# STAFF REPORT

SUBJECT: PP - H-2022-0006  
Jump Creek South Preliminary Plat

Request for a preliminary plat consisting of 20 single-family residential lots and 4 common lots on 3.57 acres of land in the R-8 zoning district, by Kent Brown.

## B. "Proposed" Jump Creek South Preliminary Plat (date: 9/24/2021)

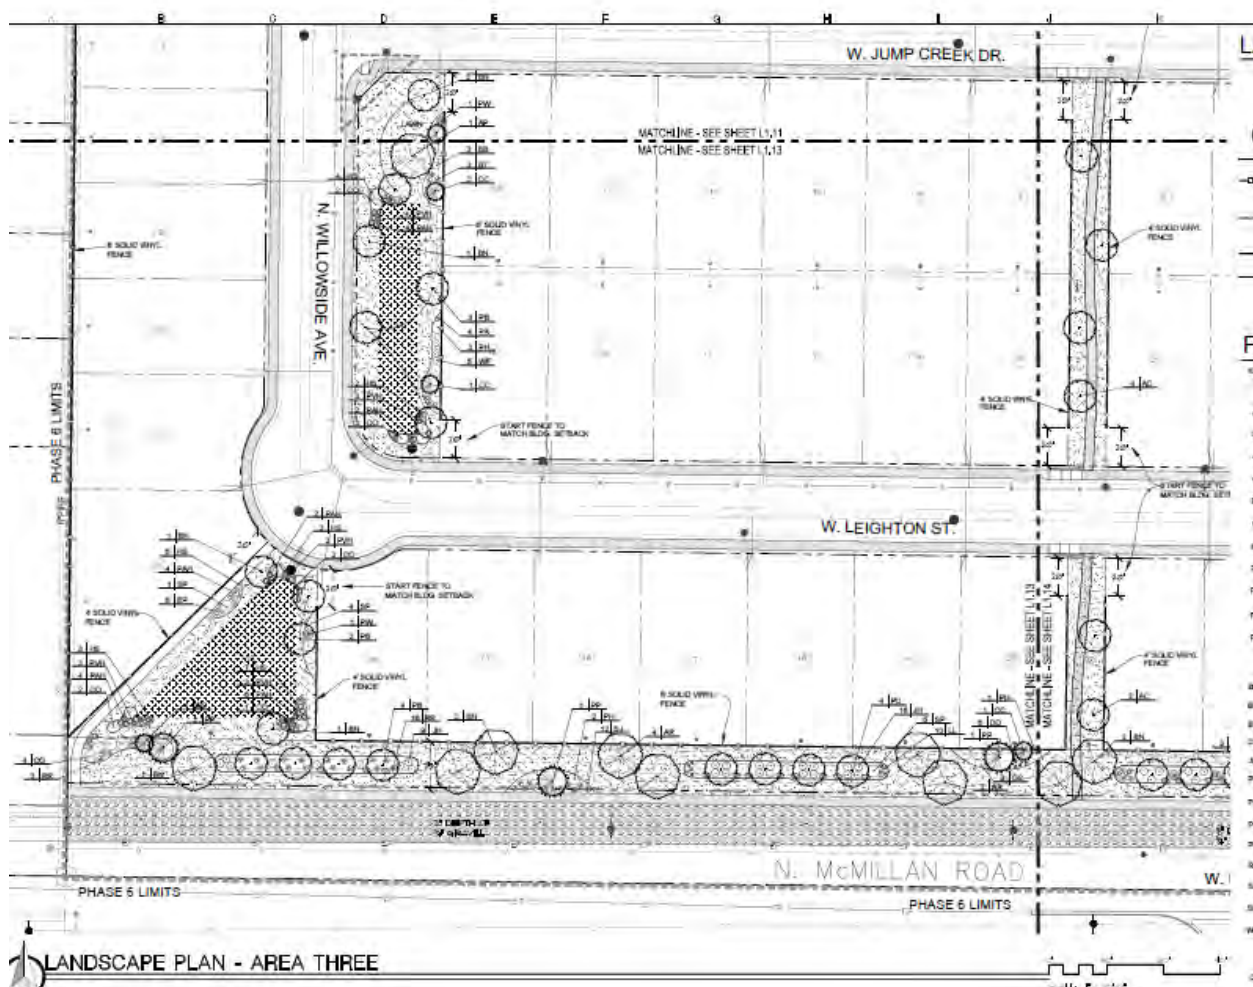
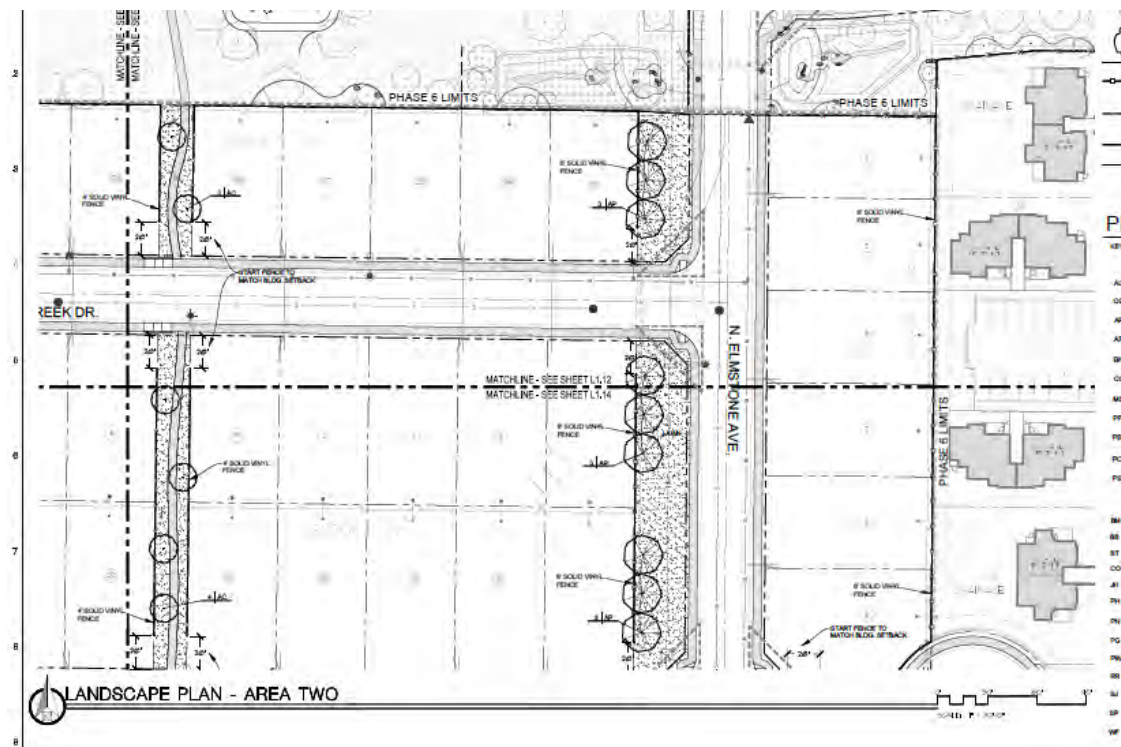
1. The Preliminary Plat included in Section VI, is approved with the following revisions:
  - a. Add date to the plat.
  - b. Revise Preliminary Plat name to read “Jump Creek South Subdivision.

LANDSCAPE PLAN - AREA FOUR

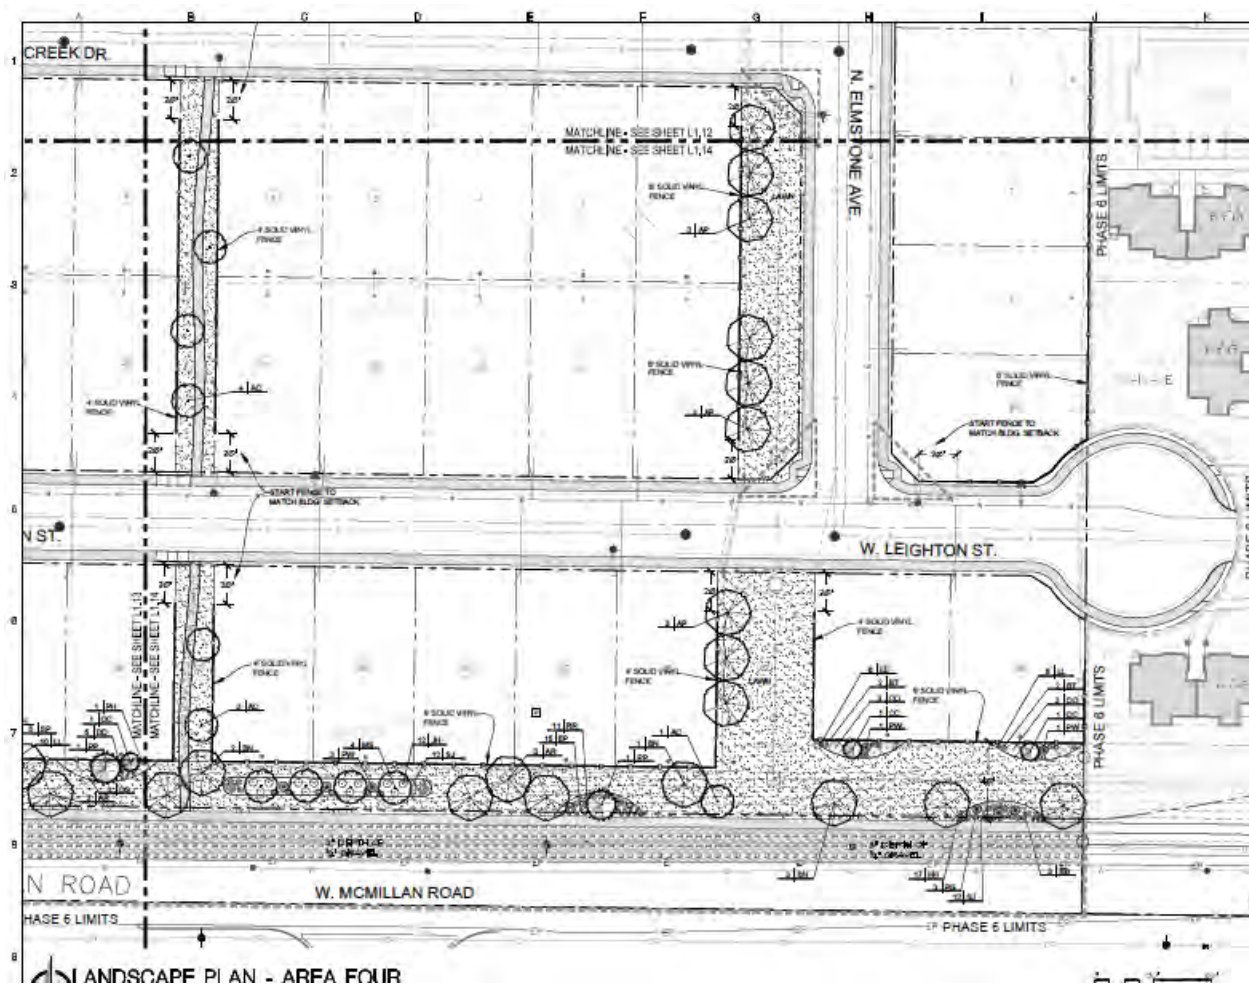
The landscape plan does not indicate whether there are healthy existing trees meeting the preservation requirements on the property. With the submittal of the final plat the applicant should submit a revised landscape plan that details any mitigation plan outlined by the developer and the City Arborist.

2. The Landscape Plan included in Section VI, dated 11/2/2020, is approved with the addition that the landscape plan shall indicate whether there are healthy existing trees meeting the preservation requirements on the property.
